TEMPORARY PRODUCTION DEVIATION

Document Number 211 (REV 2)

150M AM

150M REV2
PWB636E COMPONENT SIDE
1-8-03

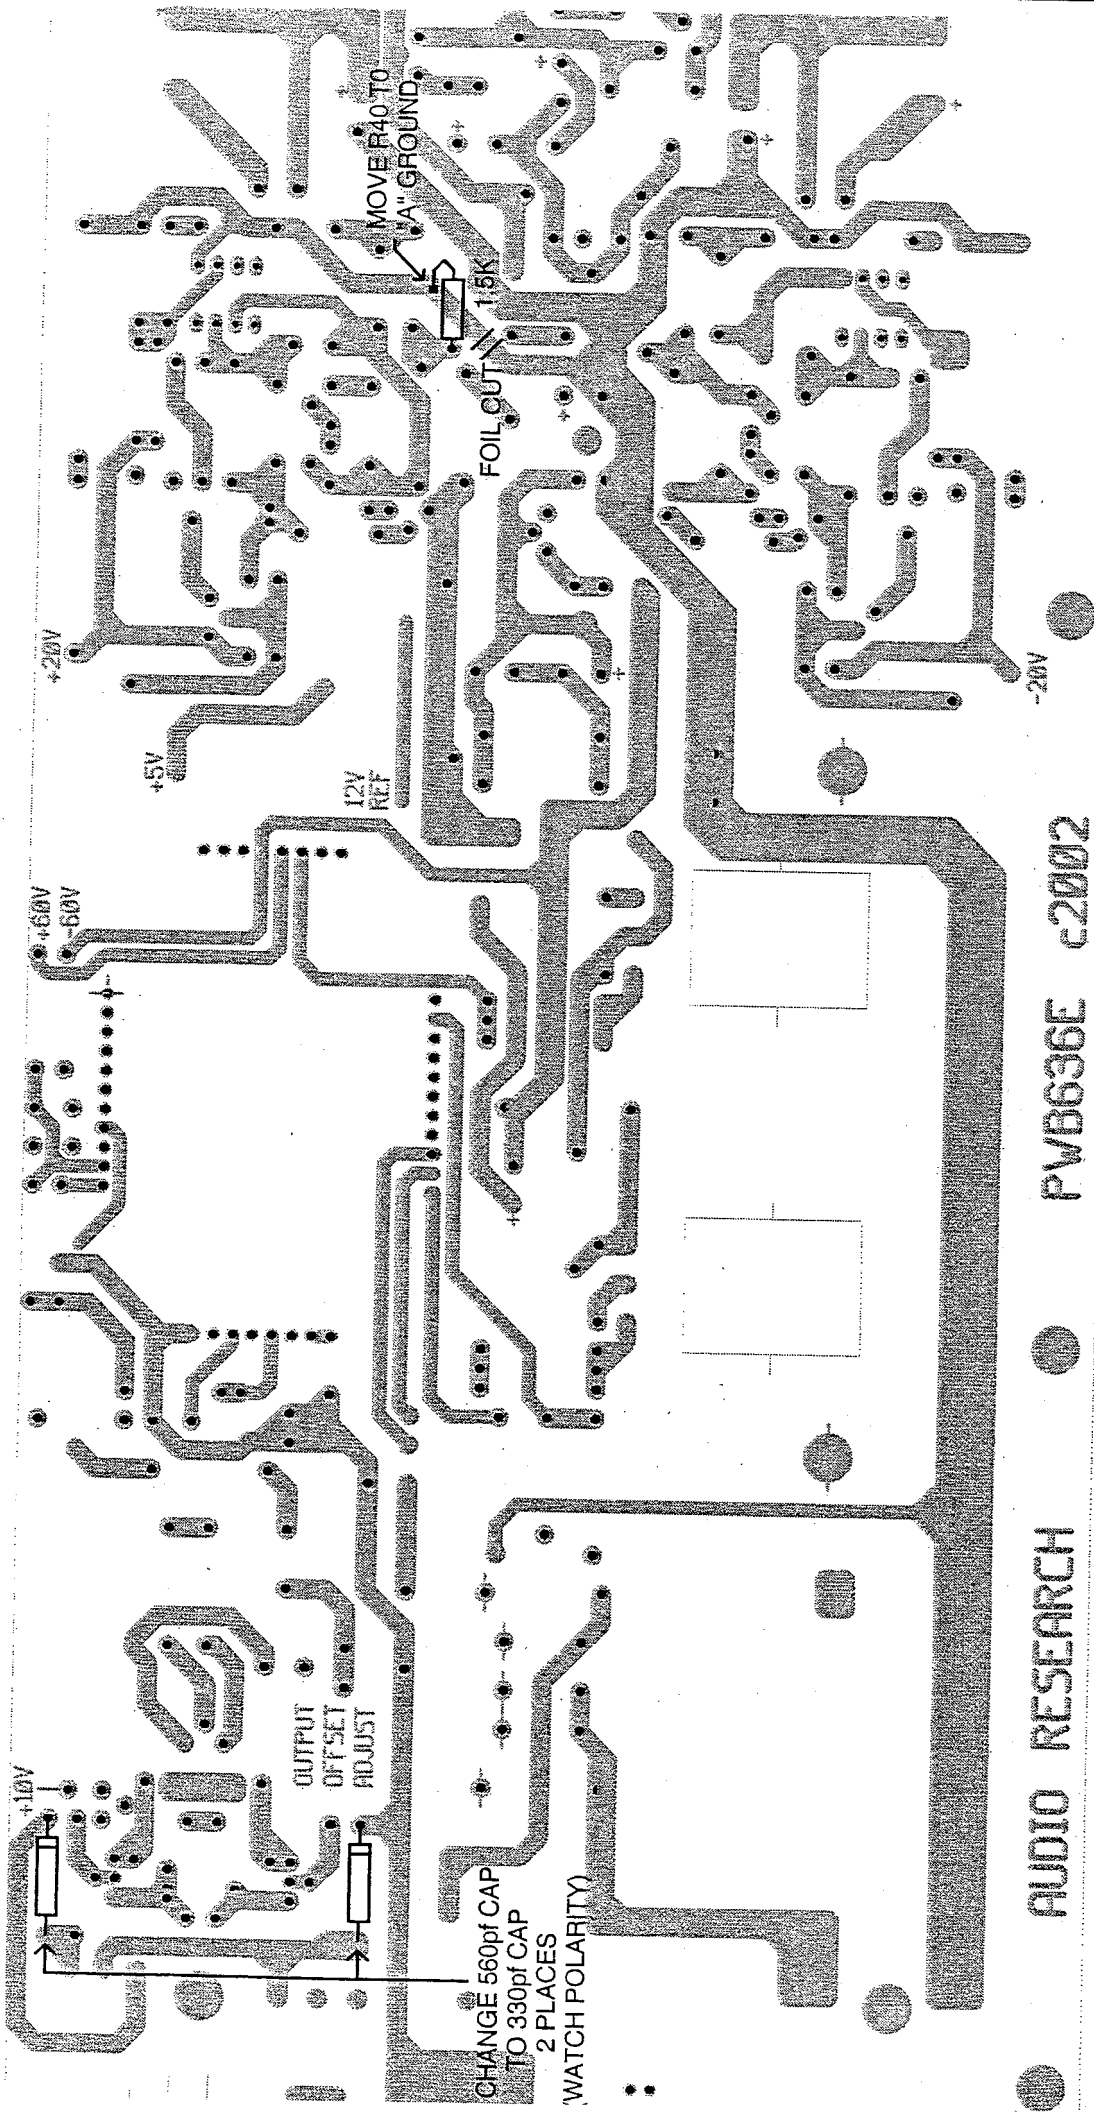
Reduces noise 6-8 db and improves sonics

Delete qty 2 of p/n 53560201 CAP., 560pF $\pm 2.5\%$ 630V (C97,98) for a new total of 0

Add qty 2 of p/n 53330201 CAP., 330pF $\pm 2.5\%$ 630V (C97,98) for a new total of 2
Add OFHC jumper solder side per print

Do foil cut and move R40 (1.5K) to ground per print
